Disability Access Report

Australian Property Development Services Pty Ltd

St Paul's Anglican Church
Corner of Moseley Street & Vickery Avenue,
Carlingford, NSW

07 December 2021

Figure - level 1 plan by Stanton Dahl Architects

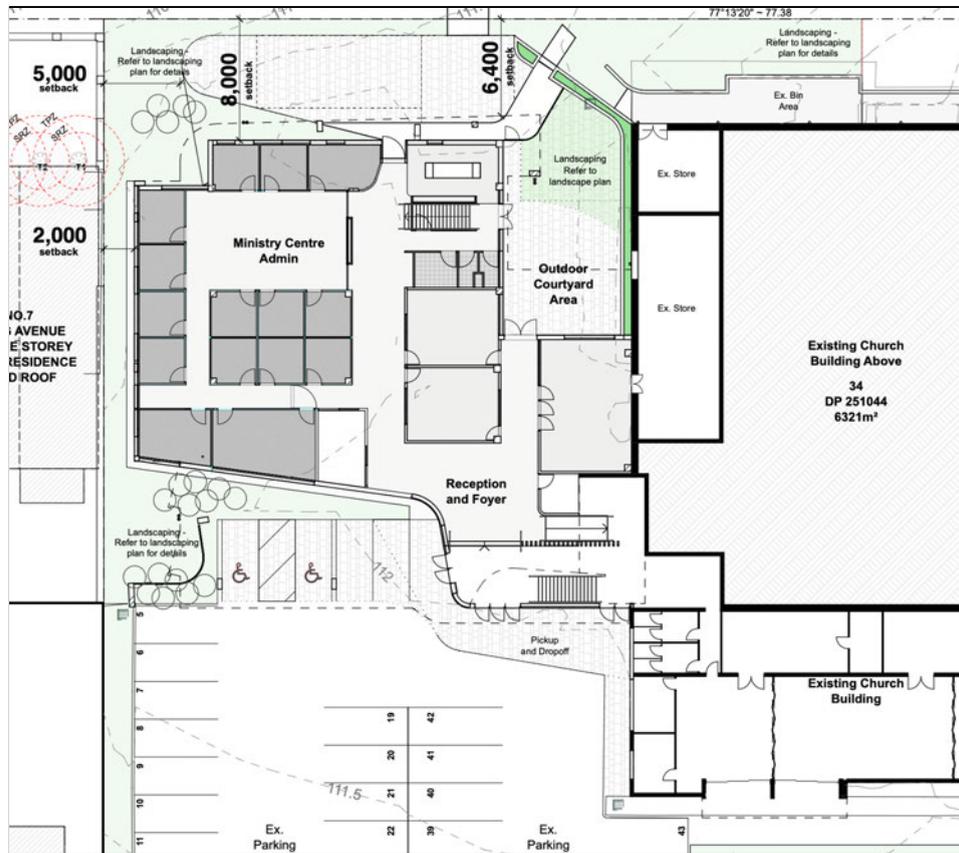
1. An accessible pathway from Vickery Avenue (street level) through the existing building to the new areas.
2. Access to and within all areas normally used by occupants where there is provision of a lift.
3. Continuous accessible path of travel is provided to all levels where there is the provision of a lift connecting Level 1 to Level 2.
